Response to U.S. EPR Design Certification Application RAI No. 458, Supplement 8

Request for Additional Information No. 458(5149, 5152), Revision 0, Supplement 8

U.S. EPR Standard Design Certification
AREVA NP Inc.
Docket No. 52-020
SRP Section: 03.09.01 - Special Topics for Mechanical Components
SRP Section: 03.09.02 - Dynamic Testing and Analysis of Systems Structures and Components
Application Section: 3.9

Figure 03.09.02-149-1—Velocity and Density Distribution for CRGA Support Column

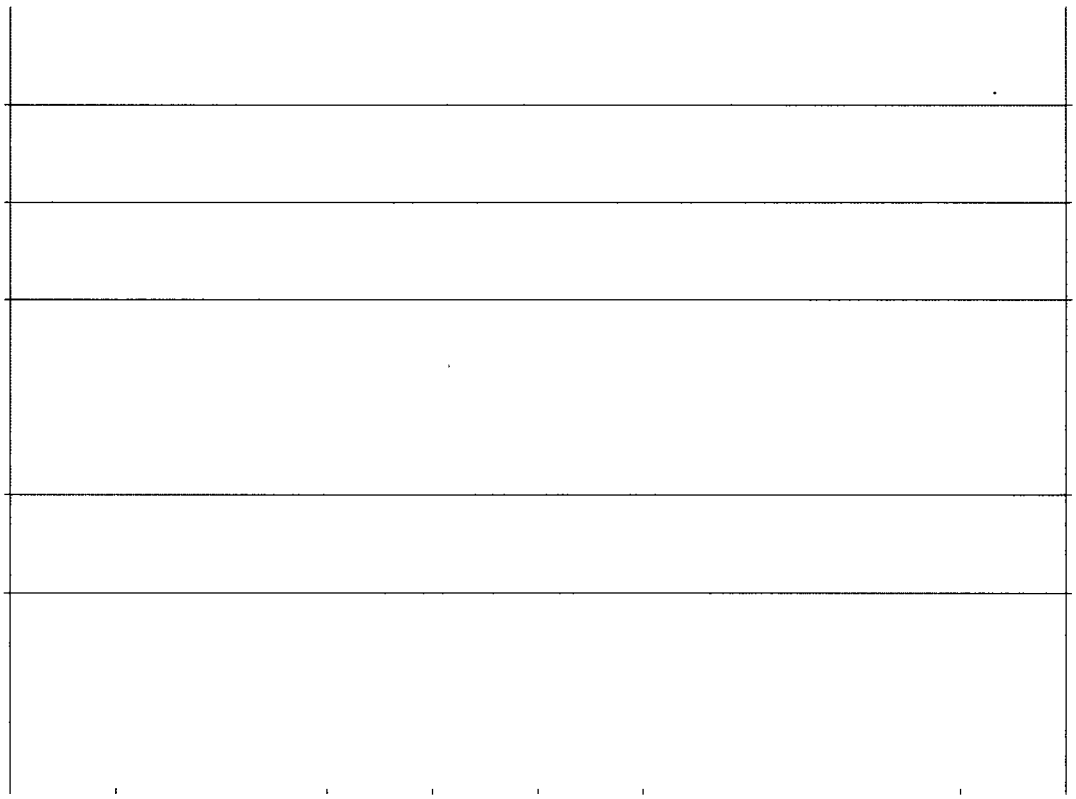
B. Provide tables of resonant frequencies, flow rate, shedding frequency (for the upper internals) together with any possible range of lock-in and the effect of uncertainty on the lock-in parameters per the recommendation of RG 1.20.

Technical Report ANP-10306P, Section 4.5.3 will be revised to add a table comparing the natural frequencies and the vortex-shedding frequencies of the column supports. The results provided in this comparison are determined considering the most limiting flow conditions for the 10 percent reactor coolant pump (RCP) overspeed transient condition and the maximum gap or pitch velocity of approximately [ ] inch/sec that occurs at a single location along the length of the column supports, which are conservative. Figure 03.09.02-149-1 and Figure 03.09.02-149-2 show the velocity profile along the length of the CRGA and level measurement probe (LMP)/normal column supports, respectively. The vortex shedding frequencies for the column supports are based on a Strouhal number of 0.46, derived from the limiting pitch velocity ([ ] inch/sec) and the P/D ratio for the CRGA columns (see Technical Report ANP-10306P, Section 4.5.1.1.2 for additional information). This value for the Strouhal number is approximately equal to the upper bound value for a single cylinder (0.47) and (0.5) for an array of cylinders.

Technical Report ANP-10306P will be revised to include the tabular comparison of natural frequencies and vortex shedding frequencies described in this response, which shows that separation exists between the fundamental frequency of the CRGA column support and its vortex shedding frequency. A comparison of the more limiting vortex shedding frequency in the drag direction (f_d = [ ] Hz) to the fundamental frequency of the CRGA (f_1 = [ ] Hz) demonstrates that the flow conditions would have to increase by a factor of [ ] in order for a resonant condition to manifest itself. Based on this margin, the uncertainties and bias errors that may exist in the calculations are not significant enough for lock-in to occur for the CRGA column support.

For the instrumentation guide tube, frequency comparison shows that separation exists between its fundamental frequency and its vortex shedding frequency. A comparison of the more limiting shedding frequency in the drag direction (f_d = [ ] Hz) to the fundamental frequency of the guide tube (f_1 = [ ] Hz) demonstrates that the flow conditions would have to increase by a factor of [ ] in order for a resonant condition to occur. Based on this margin, the uncertainties and bias errors that may exist in the calculations are not significant enough for lock-in to occur for the instrumentation guide tube.

1. Representative of the full power, steady state normal operating condition.
2. The thermal hydraulic conditions in this figure are representative of location S6 in Technical Report ANP-10306P, Figure 5-10.
3. This velocity and density profile was also applied to the instrumentation guide tube.

Figure 4-59—Acoustic Wave Impinging Normally on a Cylinder

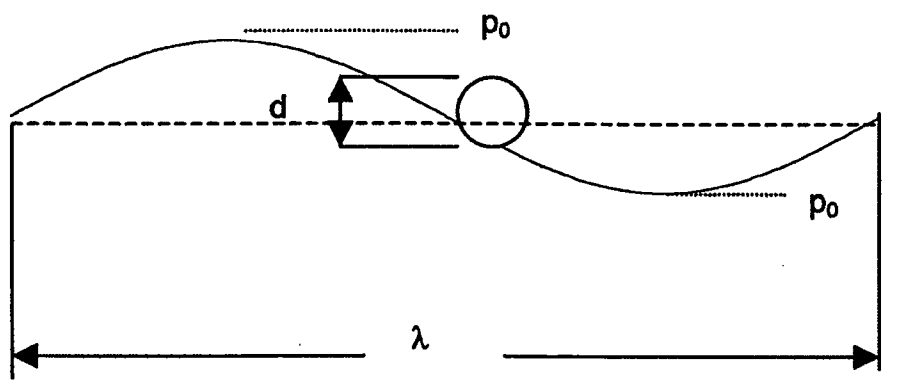
Provide justification for neglecting the tones associated with the RCP in the analysis of the RPV upper internals (extends RAI 03.09.021-101). Revise the CVAP to include the requested information.

Technical Report ANP-10306P, Section 4.5 will be revised to address reactor coolant pump (RCP) acoustic pressure fluctuations and to include tables that compare the natural frequencies of the support columns, the forcing frequencies of the RCP acoustic pressure fluctuations, the static force, and the amplification factor for each forcing frequency. The stress induced in the support columns by this source of excitation will be added to Technical Report ANP-10306P, Table 4-20.

The largest amplitude and resulting acoustic pressure typically occurs with the first blade passing frequency and will vary between -ΔP/2 and +ΔP/2 in a distance equal to the wave length of the acoustic pressure fluctuation. The wave length (λ) of the acoustic pressure fluctuations depends on its frequency and will vary for each RCP tone, but in general are very long wave lengths. Referring to Figure 4-59, the pressure differential (Δp) that would be imparted to these cylindrical structures with a diameter, d, by an acoustic pressure fluctuation with a magnitude equal to $\pm p_o$ and a wave length, λ, is equal to:

$$\Delta p = \frac{2 p_o d}{\lambda} \text{ psi}$$

and creates a harmonic force on the cylinder equal to:

$$F = d\Delta p = \left(\frac{2d}{\lambda}\right) p_o d \text{ per unit length}$$
